Consumers Power Company  
Palisades Plant  
Docket 50-255

CYCLE 10 TECHNICAL SPECIFICATIONS CHANGE REQUEST

PROPOSED TECHNICAL SPECIFICATIONS PAGES

MARKED UP EXISTING PAGES

FIGURE 3-0  
ASI LCD FOR Tinlet FUNCTION

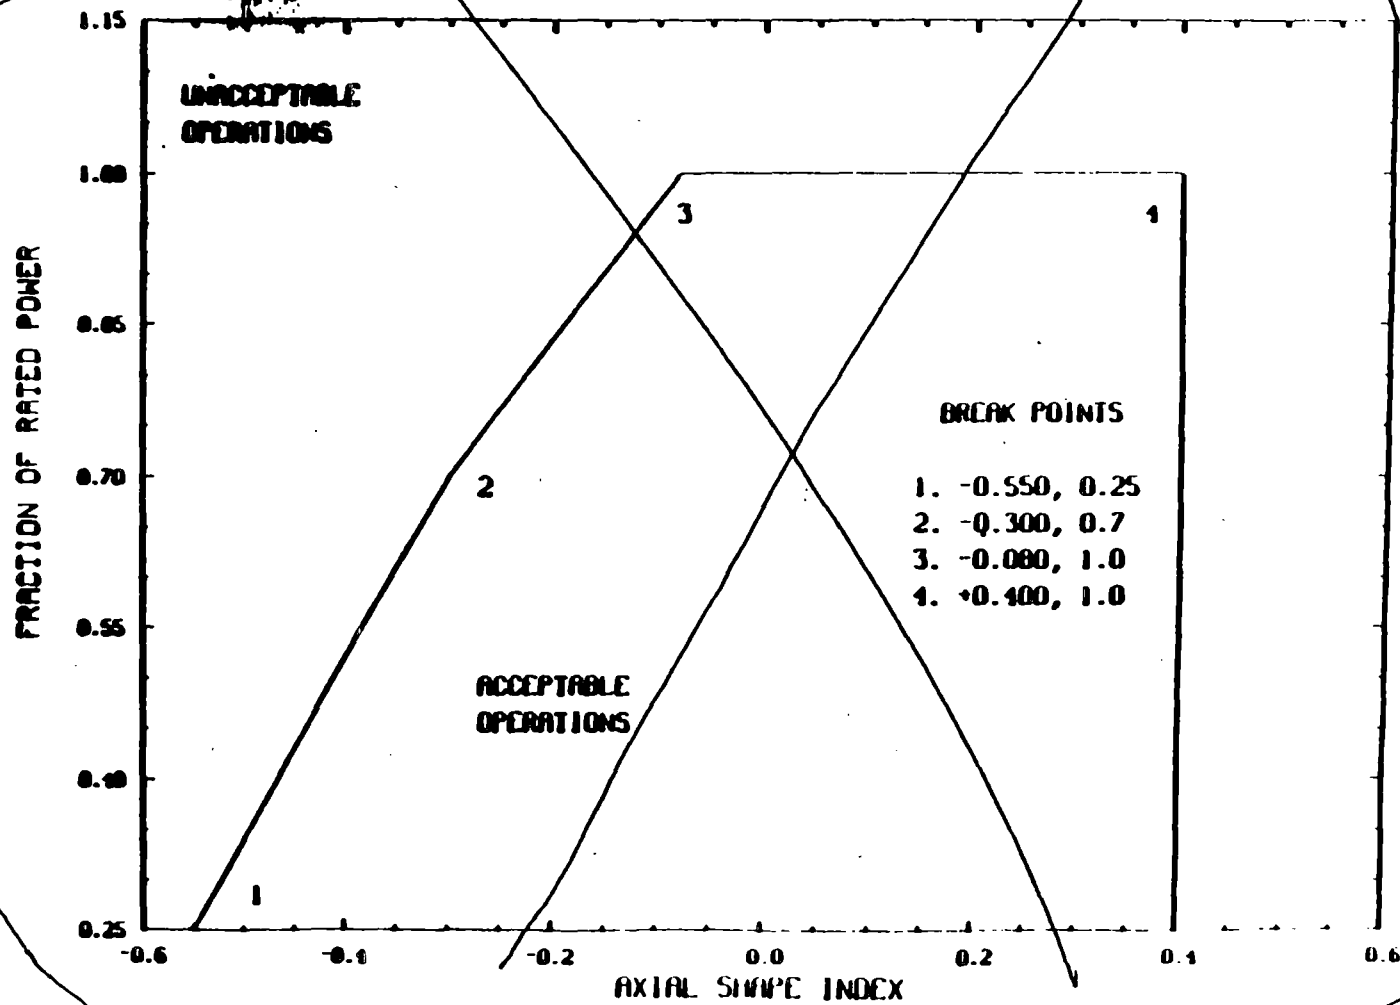
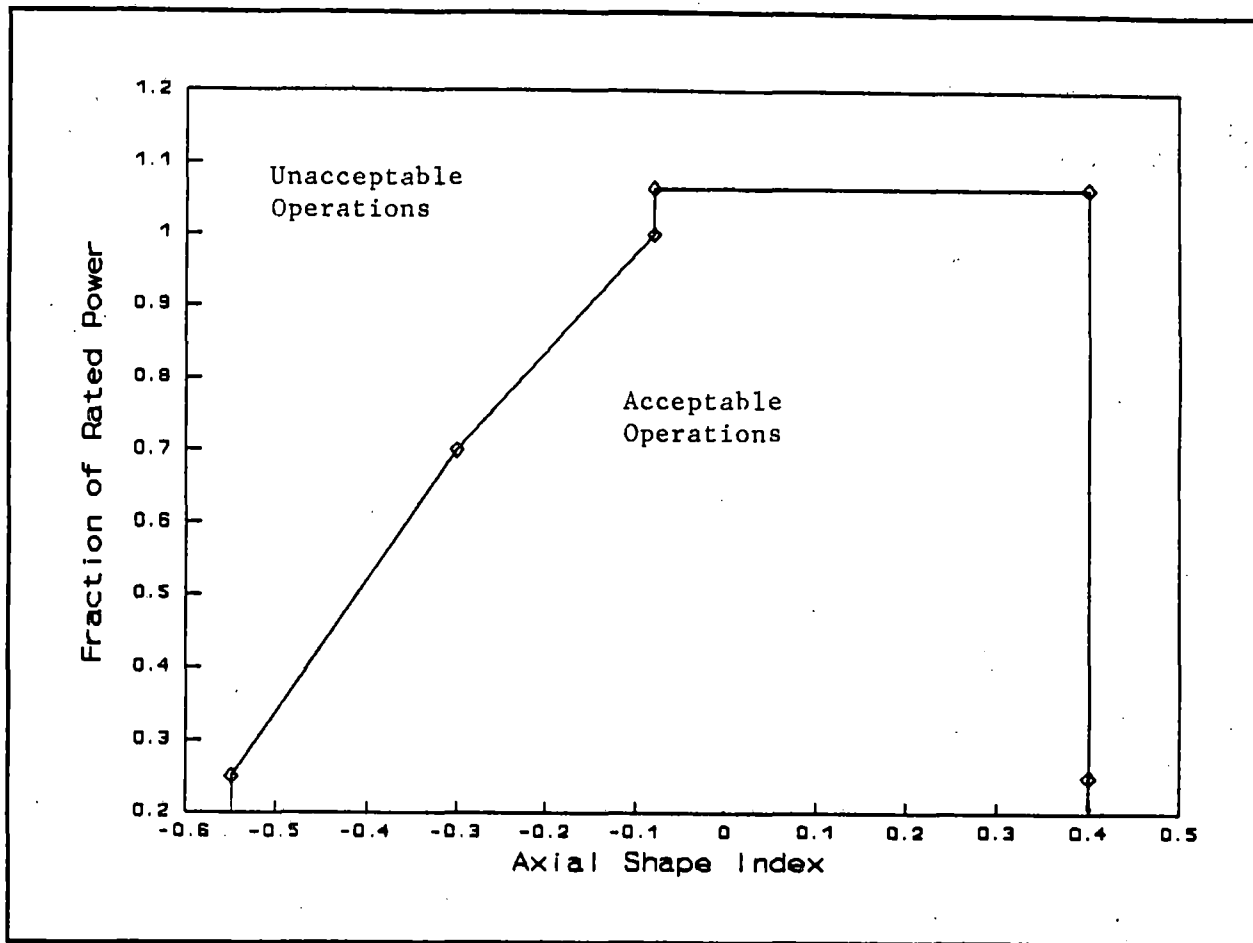
*delete now  
insert page B-3a  
which is the  
following page*

# ASI Limit for $T_{inlet}$ function

- 0.550, 0.250
- 0.300, 0.700
- 0.080, 1.000
- 0.080, 1.065
- +0.400, 1.065
- +0.400, 0.250
